Access Compliance Report

Public Rights-of-Way

(Curb Ramps)

Intersection ID: 10022963	Main Street: CEDAR_WALK_LN	Cross Street: N/A	Location: E
ADA ID: C407B233311B	Ramp Type: PerpDiag	Initial Pass/Fail: Fail	Overall Compliance: No
Severity Score: 22.5			
Codes/Mitigation Info/Possible Solution		Field Measurements/Component Compliance

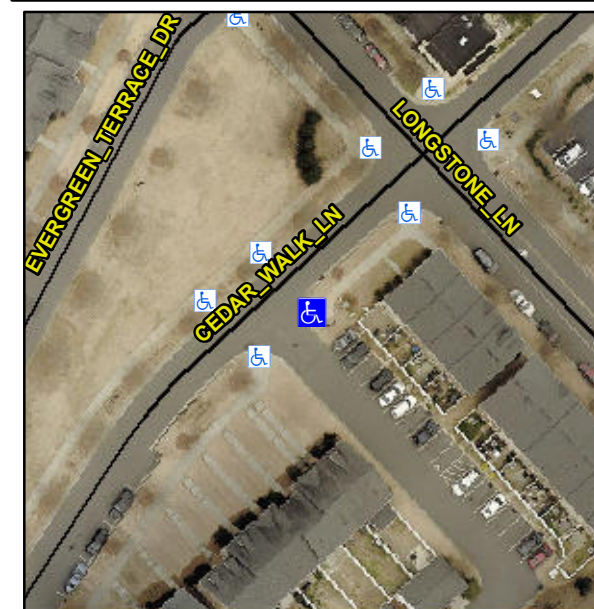
Not Found, R304.5.1, R304.2.2, R304.5.3

Compliance	Description	Data	Compliance	Description	Data
N/A	Ramp Length (in)	144.0	No	Ramp Slope (%)	8.4
No	Ramp Width (in)	46.5	No	Ramp XSlope (%)	4.2
N/A	Flare Type LT	N/A	N/A	Flare Type RT	N/A
N/A	Flare Slope LT (%)	N/A	N/A	Flare Slope RT (%)	N/A
N/A	Flare Traversable LT?	N/A	N/A	Flare Traversable RT?	N/A
N/A	Landing Length (in)	N/A	N/A	DWS Provided?	N/A
N/A	Landing Width (in)	N/A	N/A	DWS Contrast?	N/A
N/A	Landing Slope (%)	N/A	N/A	DWS Length (in)	N/A
N/A	Landing X Slope (%)	N/A	N/A	DWS Full Width?	N/A
N/A	Landing Curb? (Y/N)	N/A	N/A	DWS Offset (in)	N/A
N/A	Shared Landing?	N/A			
N/A	Gutter Ponding?	N/A	N/A	Gutter Slope (%)	N/A
N/A	Gutter Lip Ht (in)	N/A	N/A	Gutter X Slope (%)	N/A
N/A	Painted X Walk1?	No	N/A	Painted X Walk2?	No
	X Walk 1 Direction	To NW		X Walk 2 Direction	To SW
N/A	X Walk 1 Width (in)	N/A	N/A	X Walk 2 Width (in)	N/A
	X Walk 1 Slope (%)	1.5		X Walk 2 Slope (%)	2.0
	X Walk 1 X Slope (%)	1.2		X Walk 2 X Slope (%)	1.1

Remove & Replace Curb Ramp With Two New Directional Ramps or Equivalent.
